VW Trunk Latch Actuator Bracket Repair Kit

Part# 1J5 827 567 A-PRM

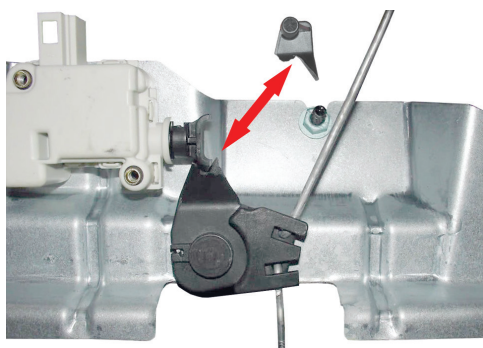
The trunk release actuator found in the VW Jetta MK4 is known for breaking the thin plastic relay lever, which disables the latch release mechanism. Repair typically requires replacement of the entire actuator bracket assembly, which is no more durable than the original failure-prone assembly.

- Actuator usage breaks the plastic relay lever, especially during cold weather
- Replacement of OE bracket assembly is a costly yet temporary repair, and doesn't resolve the fragile relay lever issue

ÜRO Parts redesigned the plastic actuator relay lever using metal for vastly improved reliability. The ÜRO lever is made of sturdy aluminum and reinforced with structural ribs, making the ÜRO lever exponentially stronger than OE. Now you can permanently repair the actuator bracket instead of replacing it!

- Improved design corrects OE deficiencies
- ÜRO relay lever is simple to install
- Aluminum construction is impervious to summer heat and winter cold
- Lifetime warranty
